From: Tang Lok San <[REDACTED]>
Sent: Thursday, January 15, 2026 10:42 PM
To: tpbpd/PLAND <tpbpd@pland.gov.hk>
Cc: [REDACTED]
Subject: A/YL-KTN/1206 - Supplementary Document

有關規劃署對 A/YL-KTN/1206 的查詢

擬議臨時貨倉 (危險品倉庫除外)
連附屬設施及相關填土工程 (為期3年)

A/YL-KTN/992 的渠務報告詳細

Proposed Fire Service Installation Plan

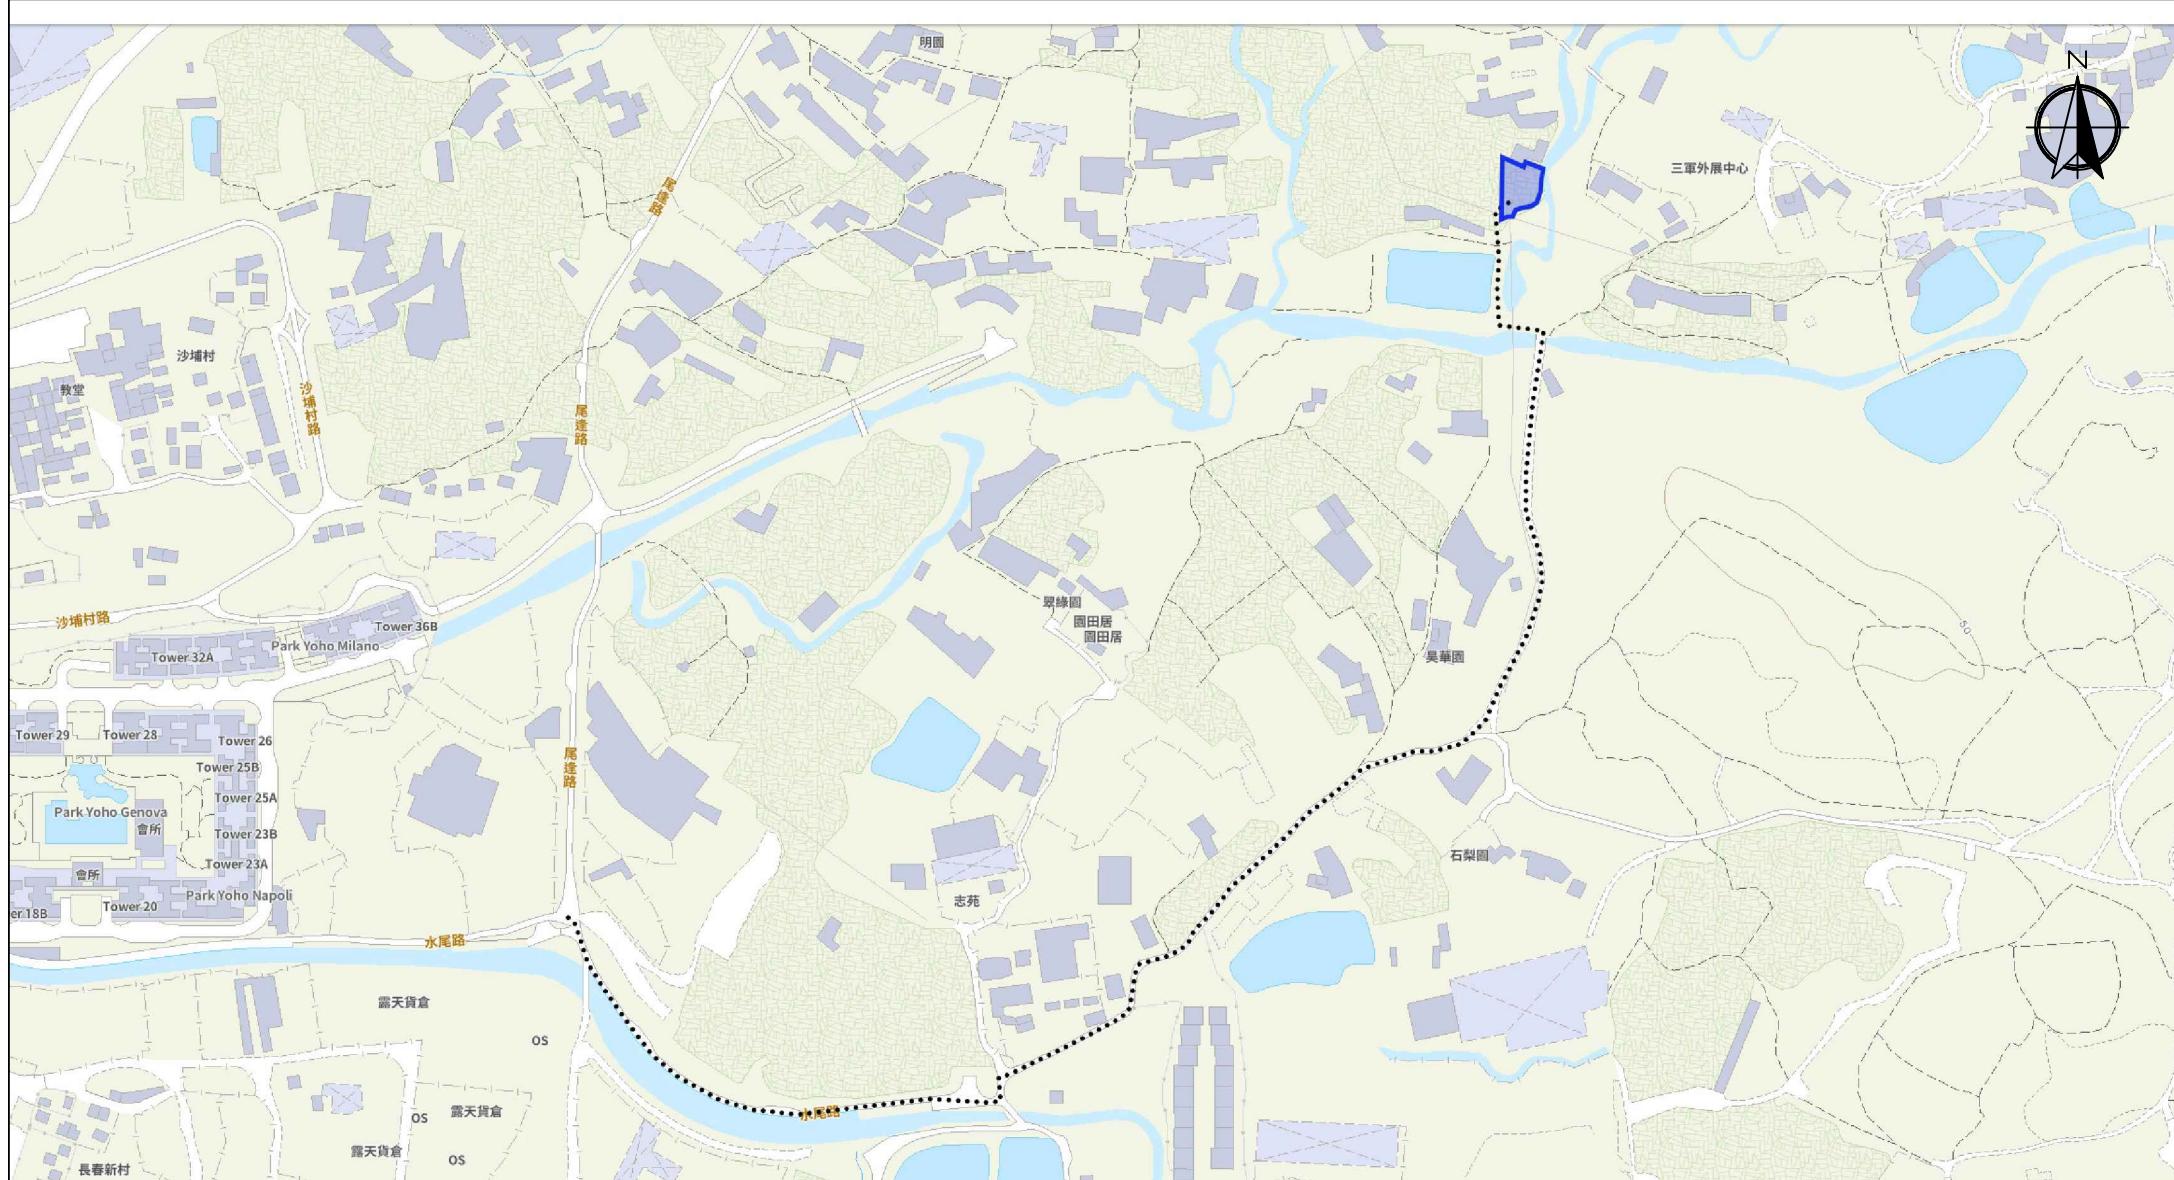
本次申請與上次(申請編號:A/YL-KTN/992)，用途及申請範圍相同，本人對上次申請未能及時完成附加條件致歉。因未能及時獲批短期豁免書，及興建渠道的承辦商達成共識，未能在時限前完成附加條件。本次申請是希望向貴委員會申請三年的臨時用途及繼續落實分別已獲渠務署及消防處在上次申請(申請編號:A/YL-KTN/992)所接納的渠務建議及消防設置安裝建議，以履行附加條件。現附上更新後的消防設備安裝計劃圖。

Appendix 4

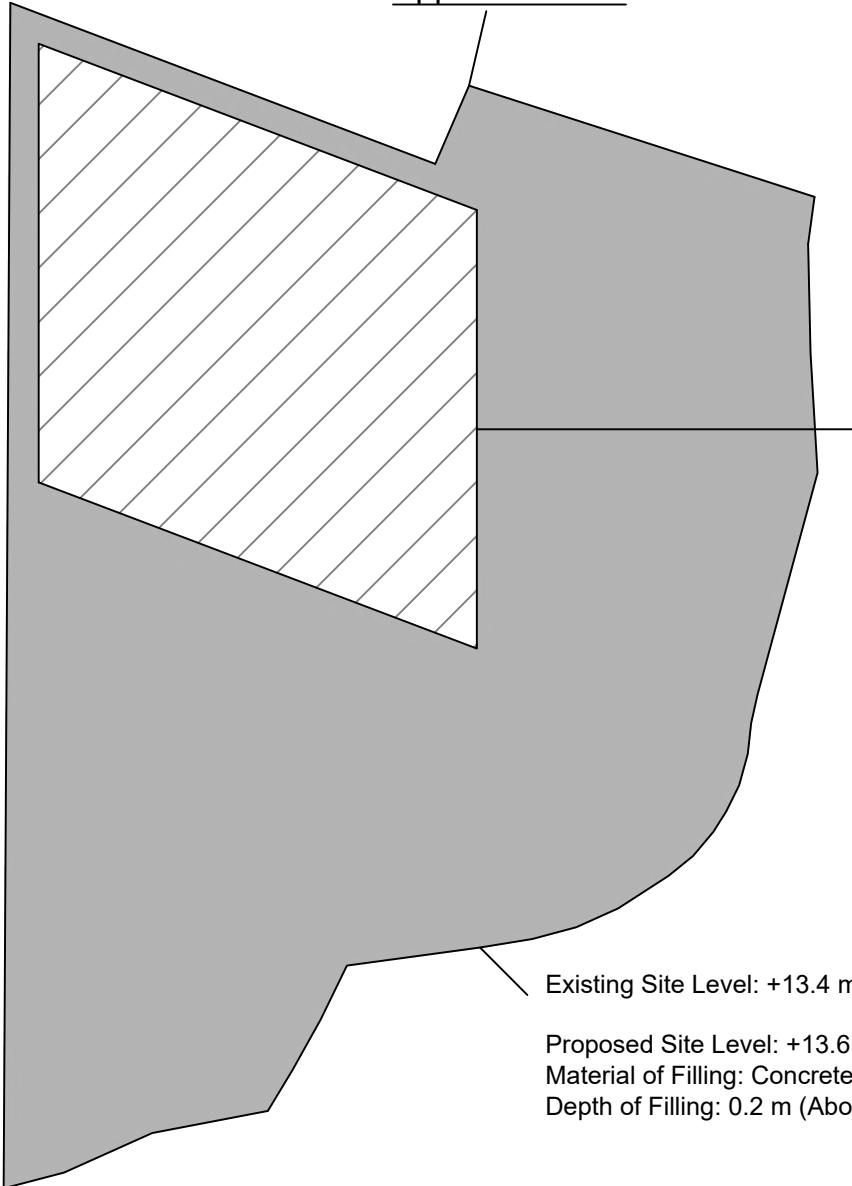
(4)	<i>Please advise if any site formation/land filling works to be carried out under this application. Please note that the overland flow from the adjacent lands should not be affected.</i>	請參考 Appendix 4，填土及平整不會影響附近流水。

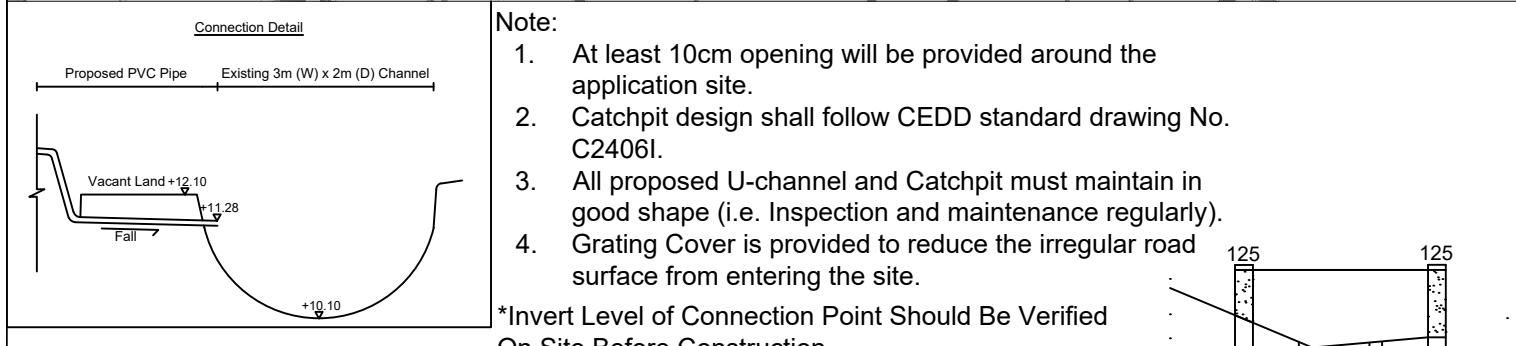
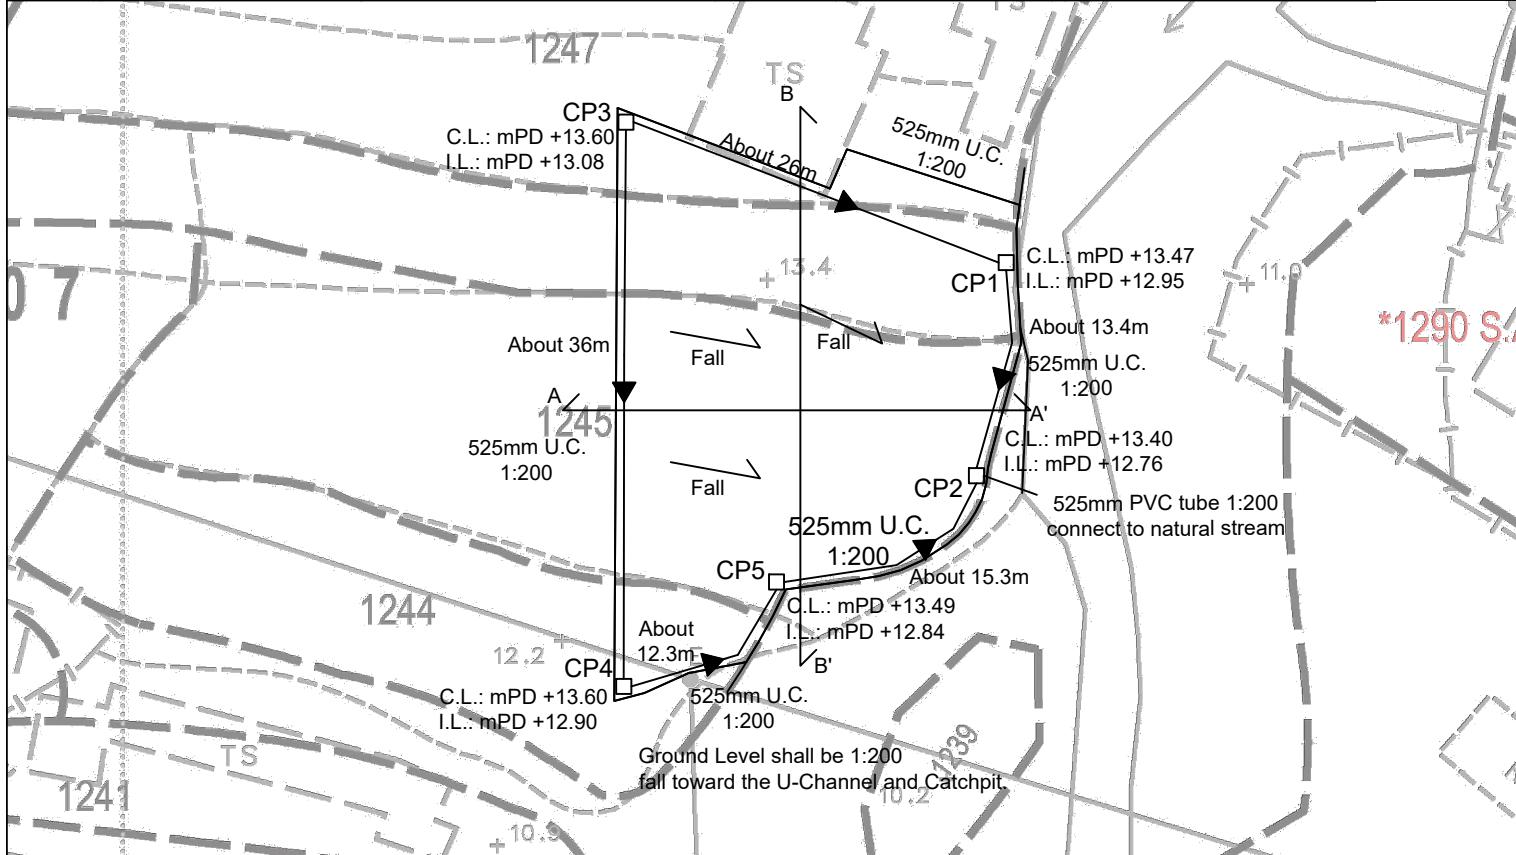
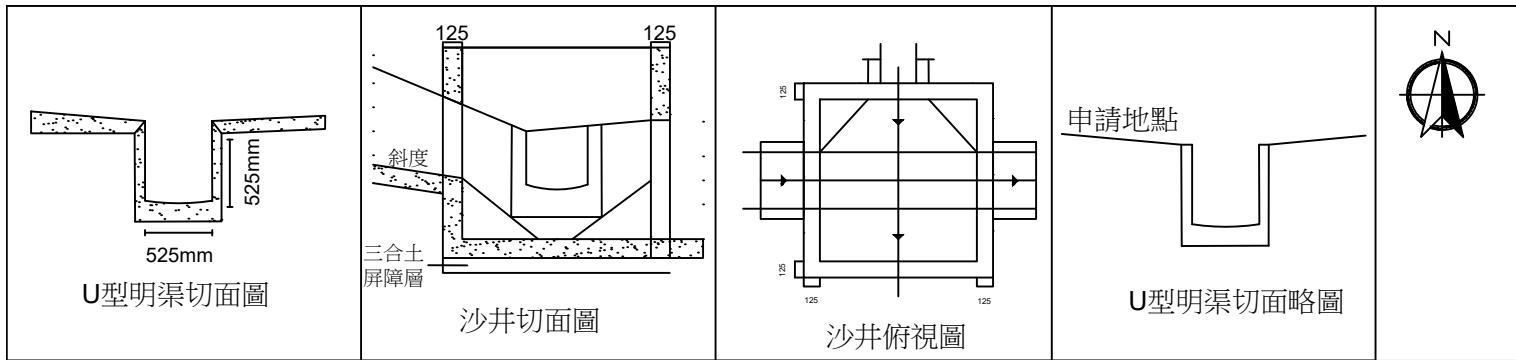
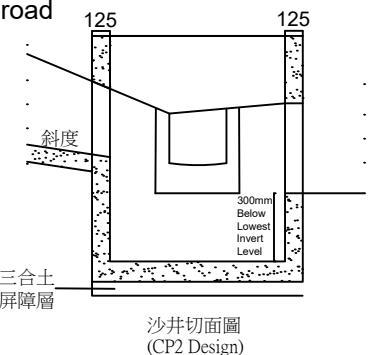
(5)	<i>Surface channels at the peripheral of the site should be constructed to intercept all such rain water falling onto the site.</i>	已依照 貴署的意見更改，請參考 Appendix 5。

(7)	<i>Please review the all invert levels as it should be determined based on corresponding gradient proposed.</i>	已依照 貴署的意見更改，請參考 Appendix 5。
(8)	<i>The capacity checking of existing natural stream does not include the downstream flow.</i>	已依照 貴署的意見更改，請參考 Appendix – Calculation。

(9)	<i>The proposal should indicate how the runoff (the flow direction) within the site would be discharged to the proposed u-channel.</i>	已依照 貴署的意見更改，請參考 Appendix 5 。

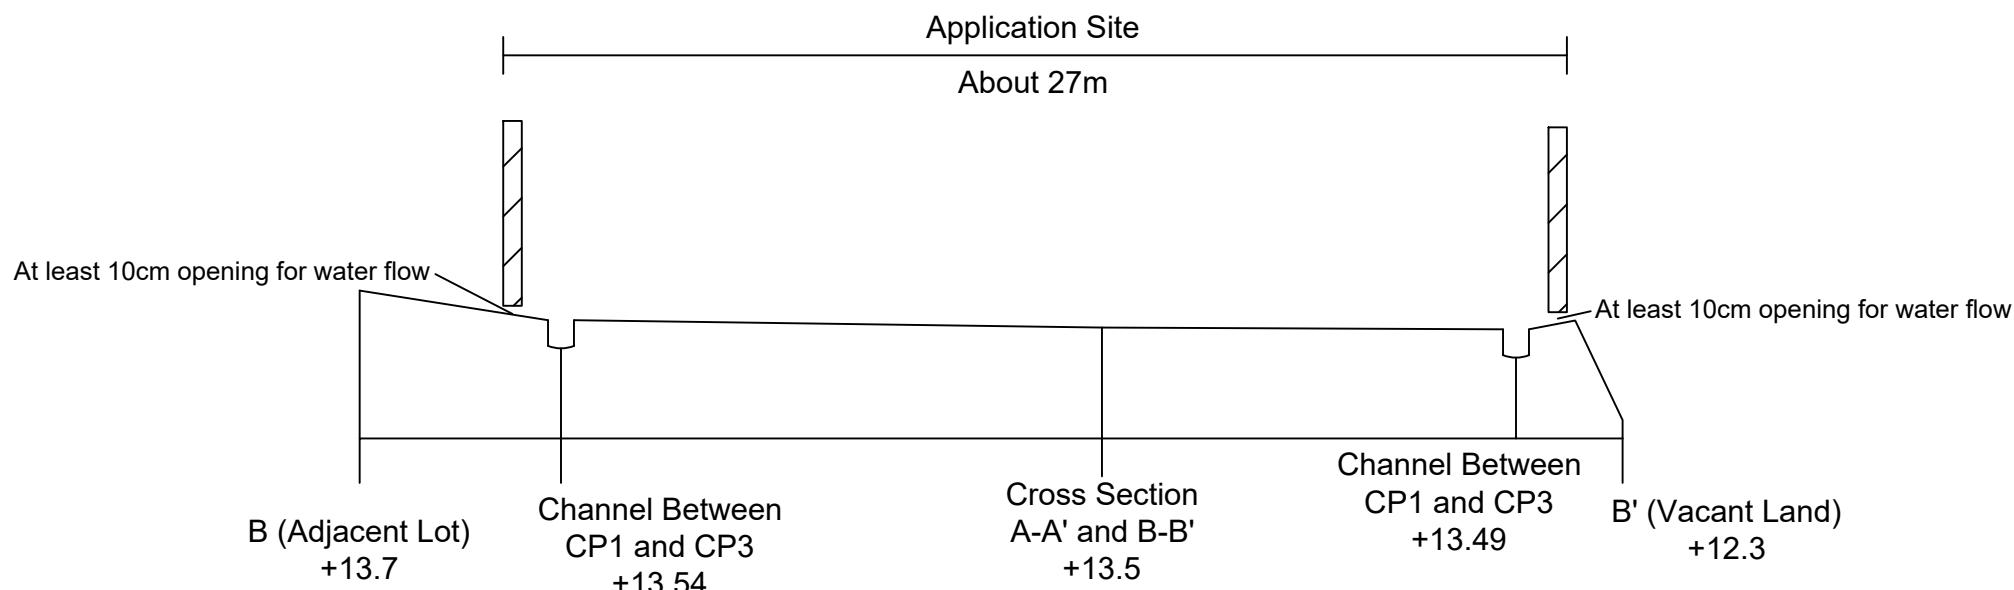
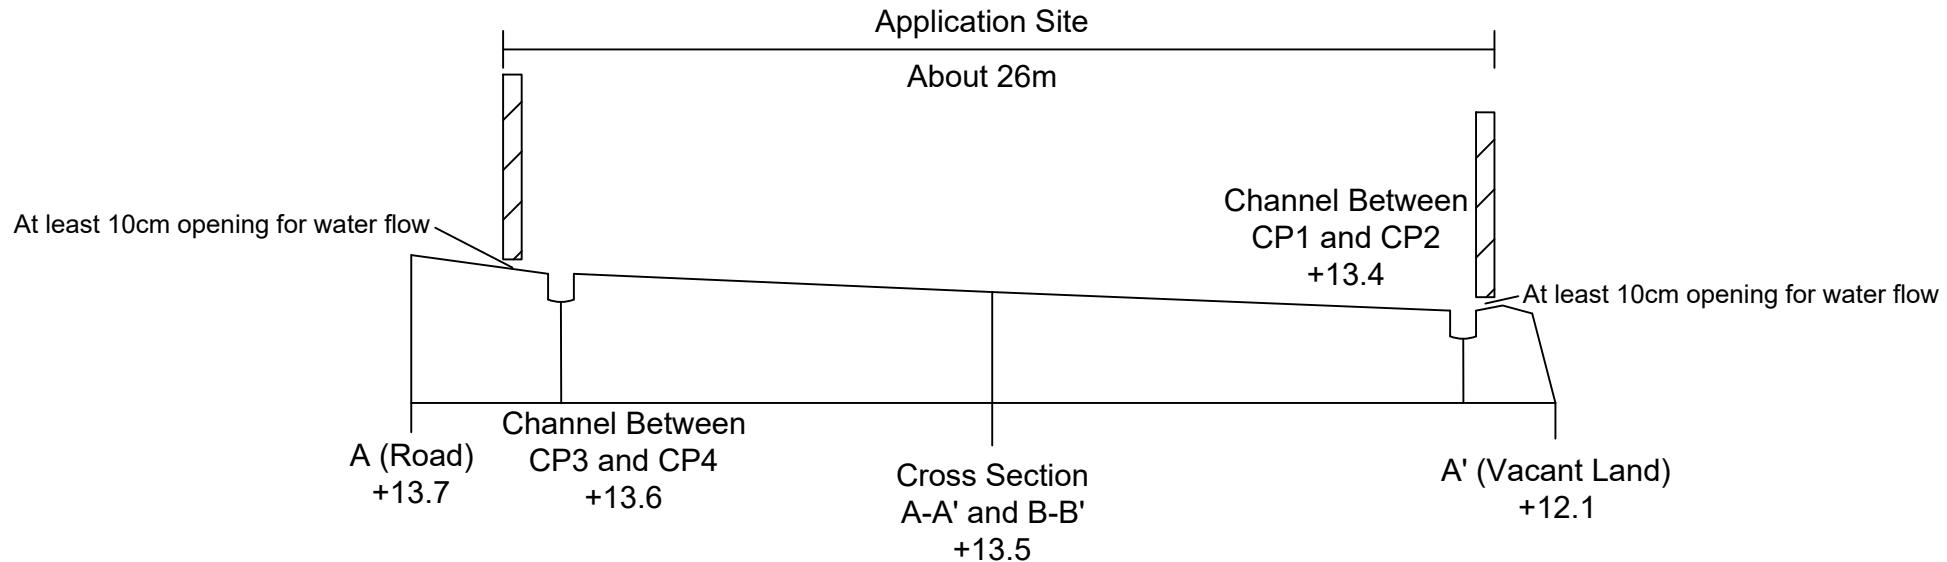
渠務署意見	申請人回覆
(1)	<i>The rainfall intensity is not correct. Please review the calculations.</i>	請參考 Appendix – Calculation，已修正該錯誤。
(2)	<i>Please provide all drainage facilities and hoarding/fencing with adequate opening, if any, in the section drawings.</i>	請參考 Appendix 5.1。

(12)	<i>Please clarify whether any walls or hoarding would be erected along the site boundary. Where walls or hoarding are erected are laid along the site boundary, adequate opening should be provided to intercept the existing overland flow passing through the site.</i>	申請範圍將會以實心金屬板圍起，並會留有不少過 10cm 的空間讓水流通過，請參考 Appendix 5.1 。

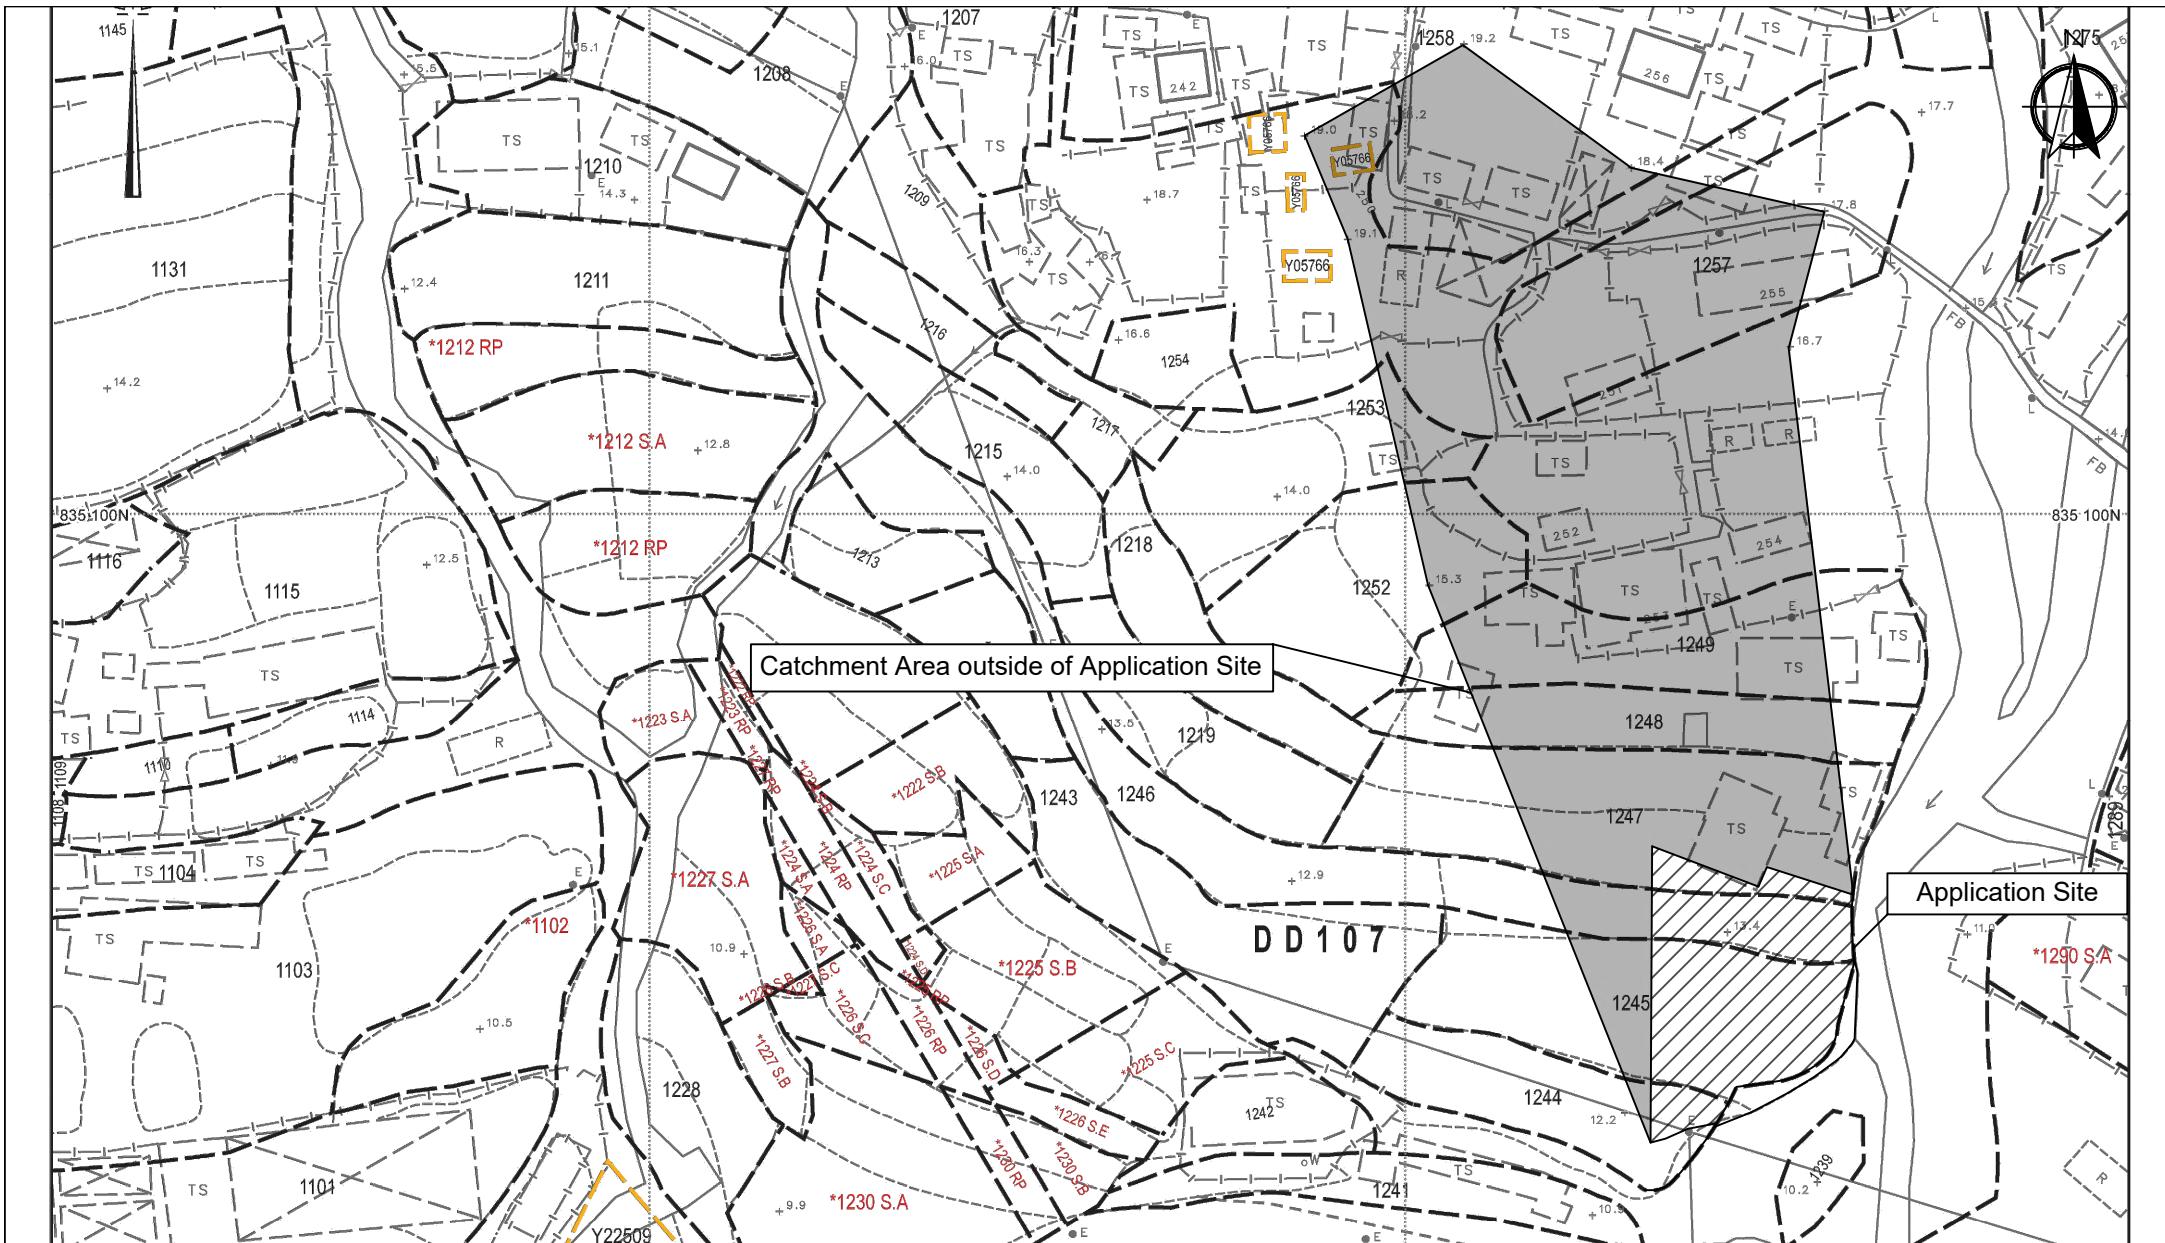
(3)	<i>Please justify the proposed catchment areas. The catchment areas should be determined according to existing topographic levels.</i>	請參考 Appendix 5.2 及 Appendix 5.3。
